**NORTH KELLYVILLE NEW PRIMARY SCHOOL**

**DISABILITY DISCRIMINATION ACT (DDA) COMPLIANCE REPORT  
SCHEMATIC DESIGN / DA STAGE REVIEW**

**AUGUST 2017**

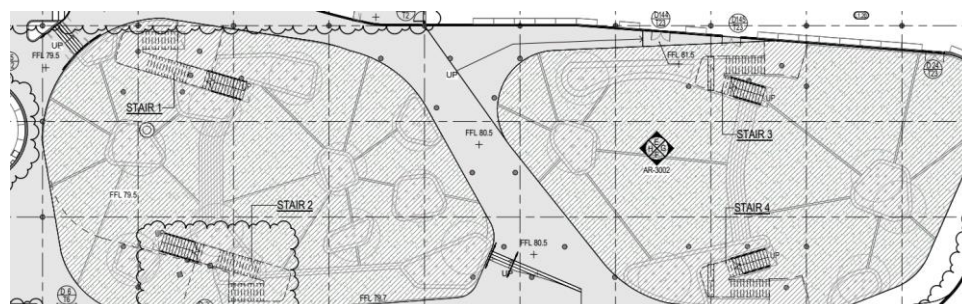
Any raised areas in the ground floor courtyard are considered to be areas that are normally used by the occupants and are required to be accessible.

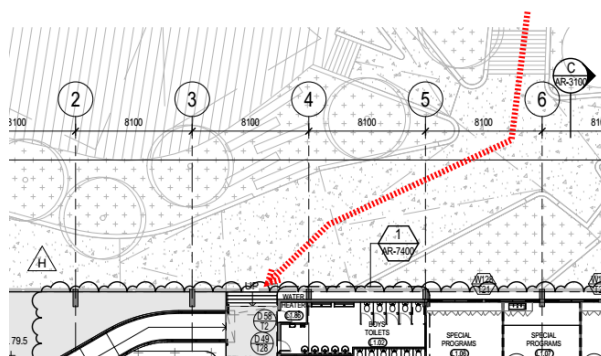
Please confirm if there is a pedestrian entry point from Thorgood Boulevard and if so if there is an accessible path of travel to the building.

The following are taken to be the accessible entries into the building, please confirm if any of these are not accessible. The stair at grid A 3 must not be more than 50m from an accessible entry.

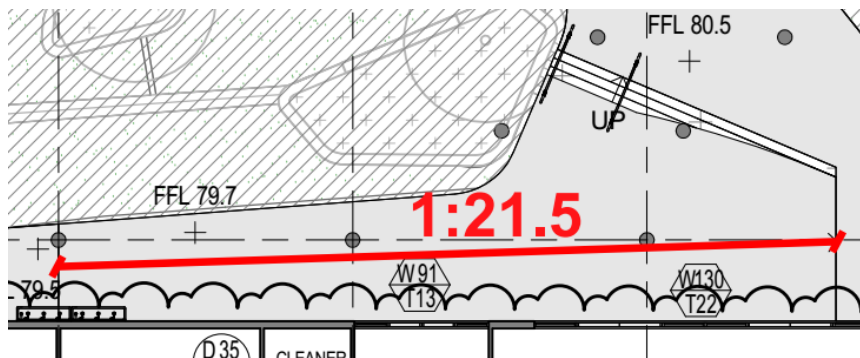
The walkway outside the library should not be designed so that it integrates with the base of the stairs, they should be separate as walkways need to be provided with edge protection (see requirements above) and stairs are required to have a landing with a maximum gradient of 1:50. This area needs to be redesigned.

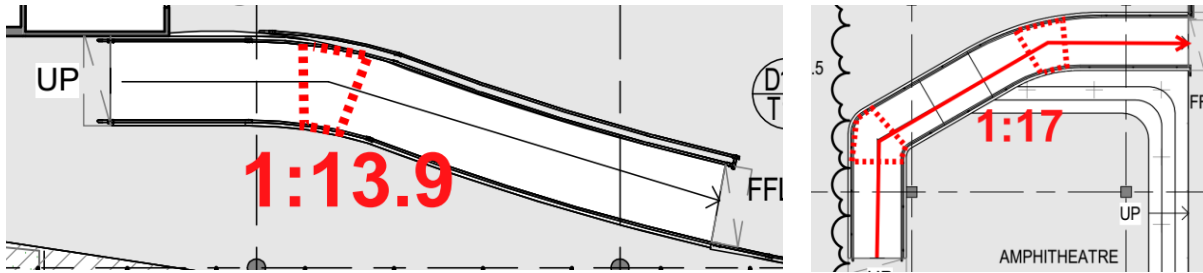
Several of the ramps are not provided with landings at all change in directions, see examples below.

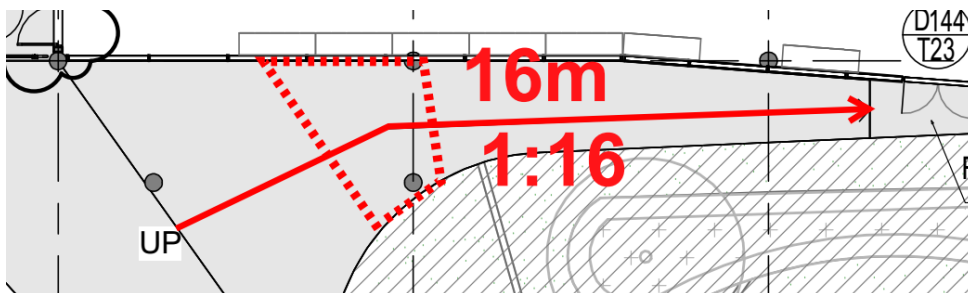
The 1:16 ramp below is required to be provided with a landing at the change in direction and handrails and kerbrails to both sides and tactiles to the top and bottom.

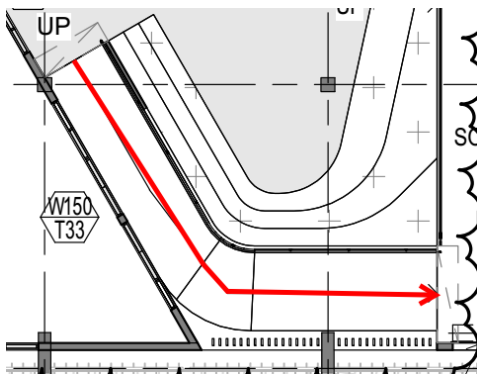
The ramp at the south entry is required to have a maximum gradient of 1:14 (it measures off at 1:13.8) and handrails and kerbrails to both sides, a set back so that the handrail extension does not protrude into the south entry and tactiles at the top and bottom.

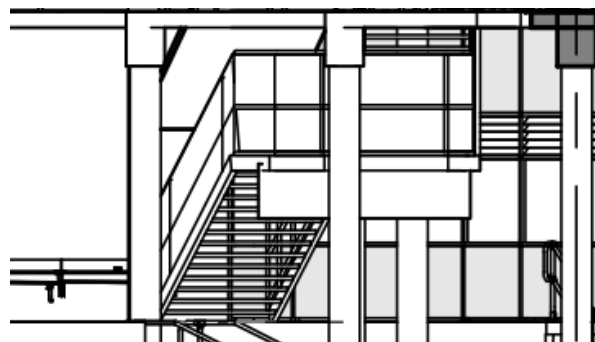
The open toe risers to the stairs are required to be closed in order to comply with the requirements of As1428.1 2009.

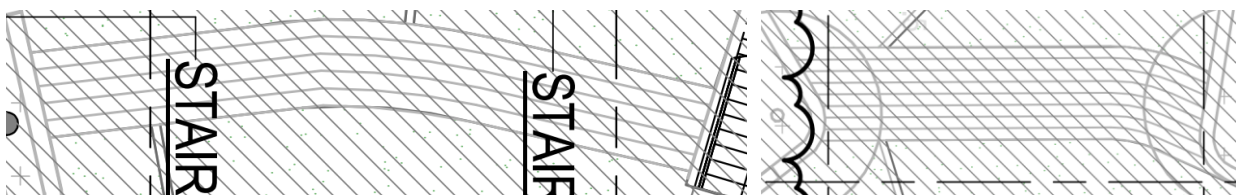
The stairs in the ground floor courtyard are required to comply with the requirements of AS1428.1 2009 and AS1428.4.1 2009.

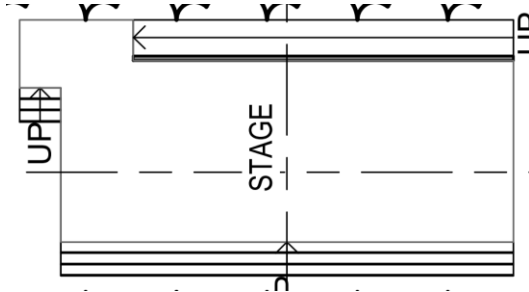
The two sets of stairs to the stage are required to comply with the requirements of AS1428.1 2009 and AS1428.4.1 2009.

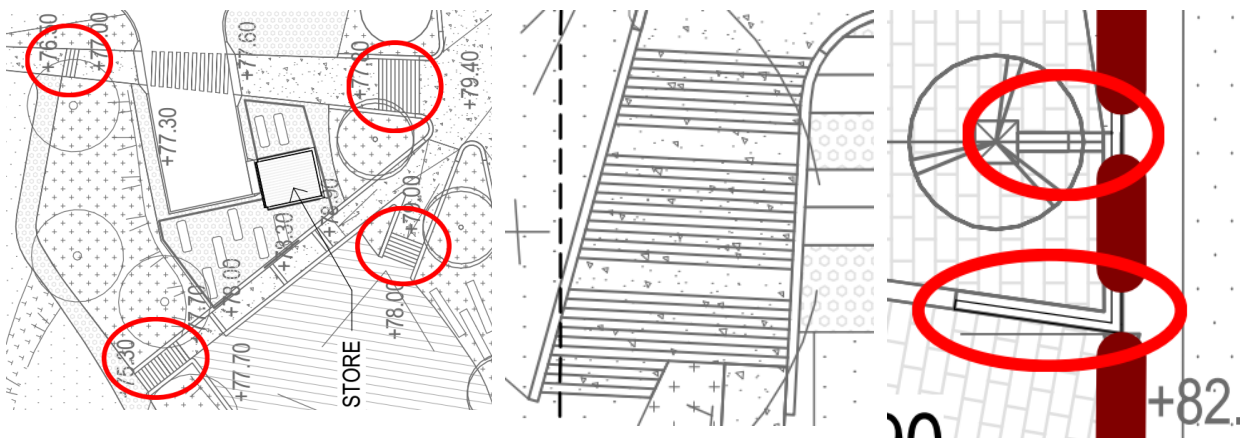
The stairs in the landscaped areas are required to comply with the requirements of AS1428.1 2009 and AS1428.4.1 2009.

Note that the requirement for handrails to be provided to both sides of stairs also applies to the tiered seating adjacent to the base of stair 5.

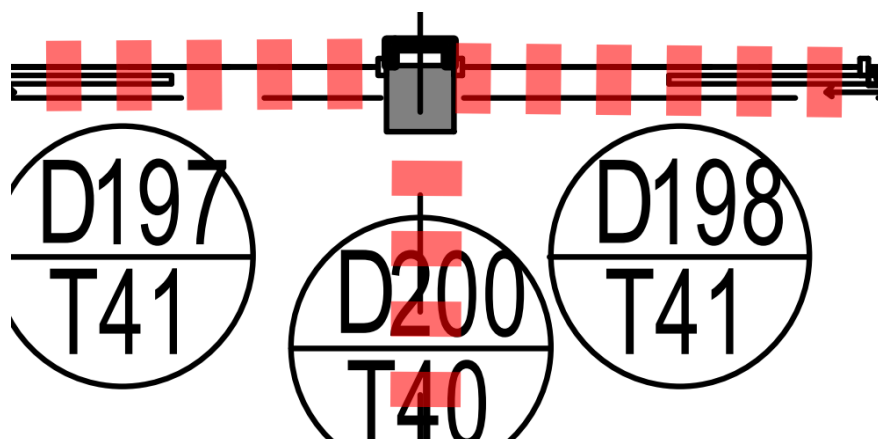
The door handles to the sliding doors to the classrooms are required to be set back a minimum distance of 400mm from internal corner formed by the folding walls and nibs so as to provide a latch side circulation space.

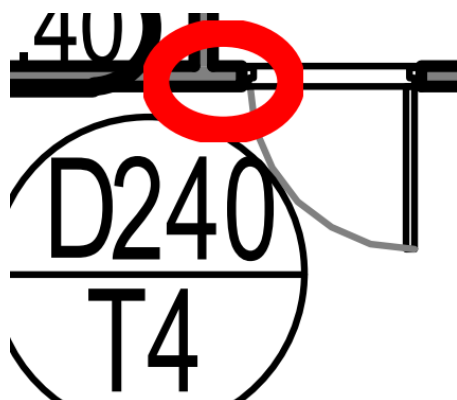
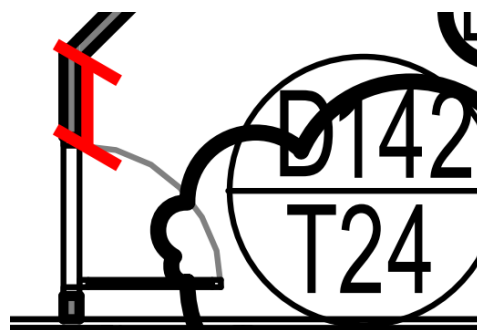
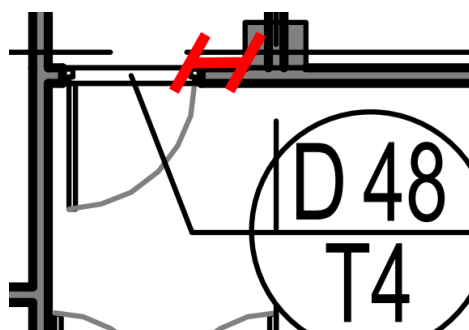
The following doorways are not provided with compliant circulation spaces and are required to be redesigned in the design development stage.

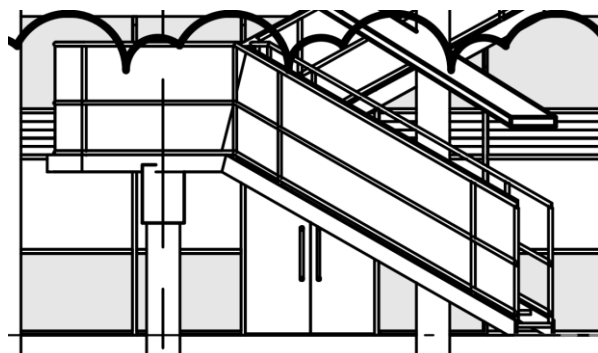
The stepped or tiered structure in the western elevation of the ground floor courtyard is considered to be a stair and is required to be provided with tactile indicators to the top and bottom as per AS1428.4.1 2009.

Where the underside of the five stairs to level 2 has a height of less than 2m and are not enclosed or provided with rails as per figure 2.6(A) of AS1428.4.1 2009 they are required to be provided with tactile indicators complying with AS1428.4.1 2009.

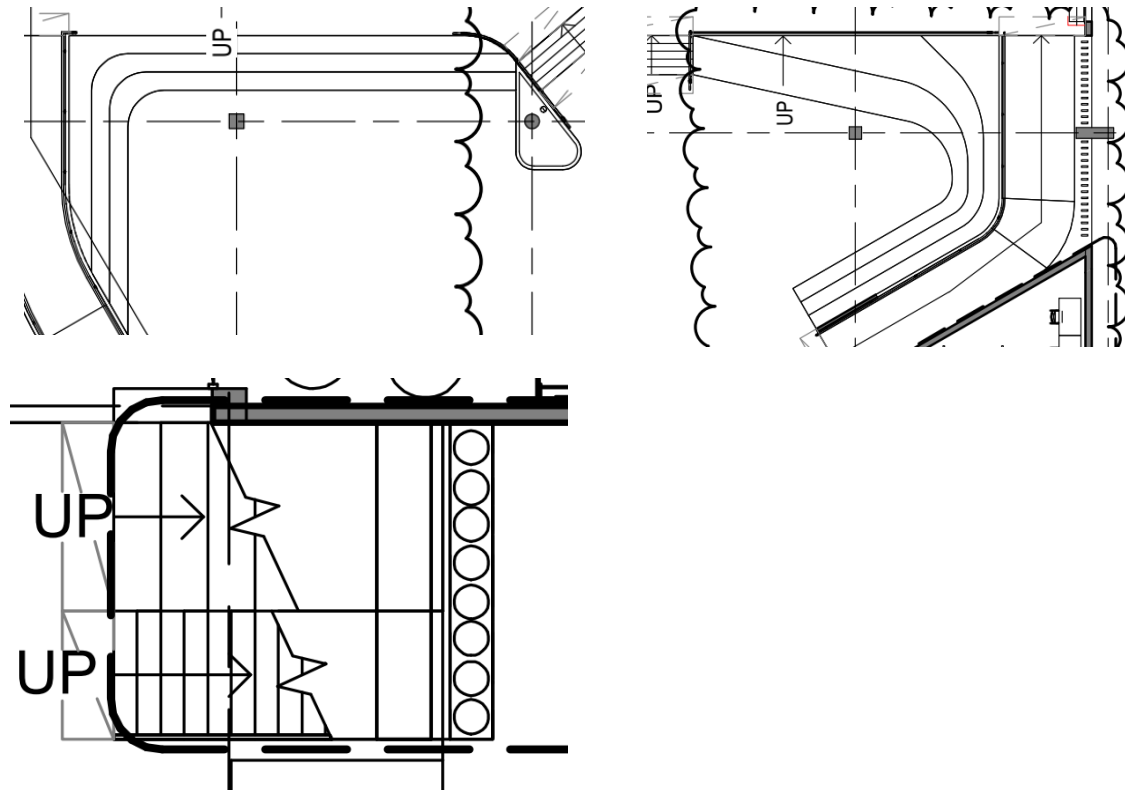
Note that the amphitheatre seating on the ground level and the tiered seating beside stair 5 is deemed to be fixed seating in a Class 9b building and is required to be provided with wheelchair seating spaces as per the BCA and AS1428.1 2009 or they can be addressed in an alternative solution prepared by an access consultant or the lack of wheelchair seating can be noted as a non compliance on the Section 109R Crown Works Certificate and on the BCA Completion Certificate.

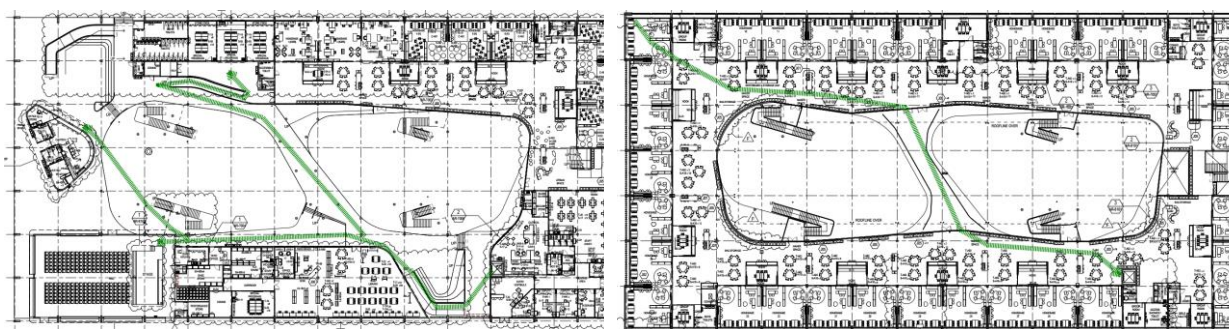
The location of the lift on the eastern side of the building means that the occupants of the western side of level 2 will have to travel a longer distance to access the unique services located on the western side of level 1 such as the Special Programs rooms, the Canteen and the Hall.
